Item Name: Crosstube Fwd

DART AEROSPACE LTD		Work Order: 78247
Description: Crosstube High Fwd (205/212/412)		Part Number: D212-664-101
Inspection Dwg: D212-664-141 Rev: D		Page 1 of 1

DRAWING NO. D212-664-141	TITLE XTUBE ASSY (205/212/412 HI FWD)	REV. D	DART AEROSPACE LTD ENGINEERING ORDER		D.E.O. NO. D212-664-141-D-1	SHEET NO. SHEET 1 OF 2	SCALE NTS
DRAWN	CHECKED	AP	MFG. APPR.	ER	APPROVED	MP	DE APPR.
DATE 11.04.07	DATE 11.07.11		DATE 11.04.12		DATE 11/04/12		DATE 11.04.12

DRAWING NO. D212-664-141	TITLE CROSSTUBE ASS'Y (205 HI FWD)	REV. D	DART AEROSPACE LTD ENGINEERING ORDER		D.E.O. NO. D212-664-141-D-2	SHEET NO. SHEET 1 OF 1	SCALE NTS
DRAWN <i>UP</i>	CHECKED <i>ASS</i>	MFG. APPR. <i>AB</i>	APPROVED <i>MD</i>		DE APPR. <i>HH</i>		
DATE 11.07.15	DATE 11.07.20	DATE 11.07.21	DATE 11/07/21		DATE 11.07.21

**D212-664-141-141B
ASSEMBLY DETAIL**

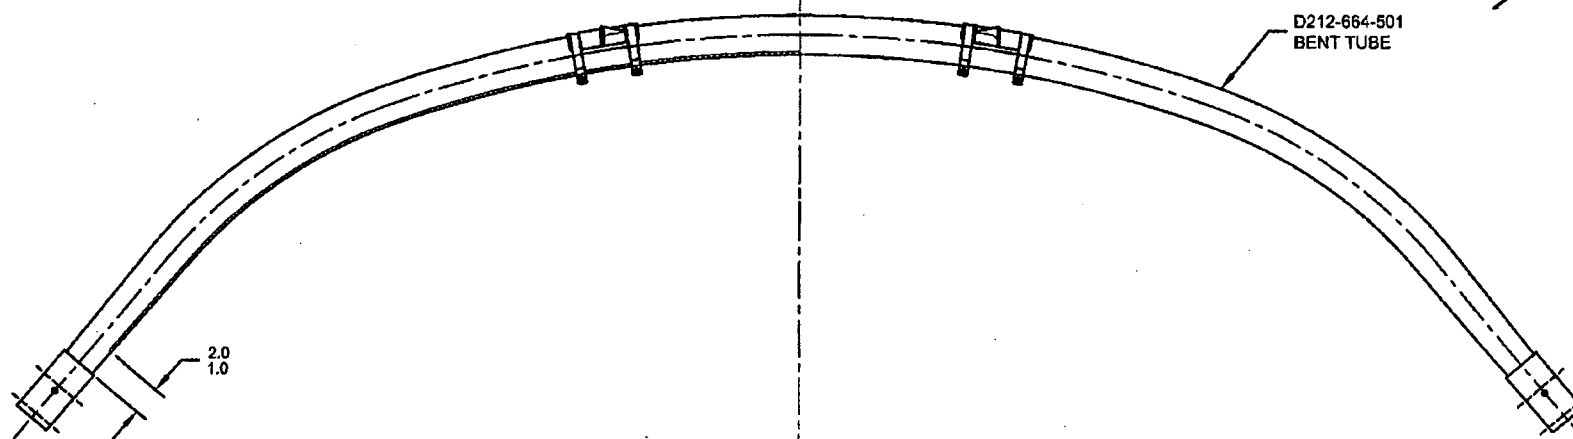
PURPOSE:

ADD AN INSPECTION WINDOW TO UNDERSIDE OF CROSSTUBE.

NOTES 2 OF SHEET 1 IS AMENDED AS FOLLOWS:

- 2) FINISH: CHEMICAL CONVERSION COAT PER DART QSI 005 4.1
PRIME INSIDE AND OUTSIDE PER DART QSI 005 4.2
MASK UNDERSIDE OF CROSSTUBE AS SHOWN (HATCHED AREA) AND
PAINT OUTSIDE PER DART QSI 005 4.2
REMOVE MASKING AND APPLY CLEAR COAT

- 2) FINISH: CHEMICAL CONVERSION COAT PER DART QSI 005 4.1
PRIME INSIDE AND OUTSIDE PER DART QSI 005 4.2
PAINT OUTSIDE PER DART QSI 005 4.2

MASK AREA PRIOR TO PAINTING,
REMOVE MASKING AFTER PAINT
AND APPLY CLEAR COAT
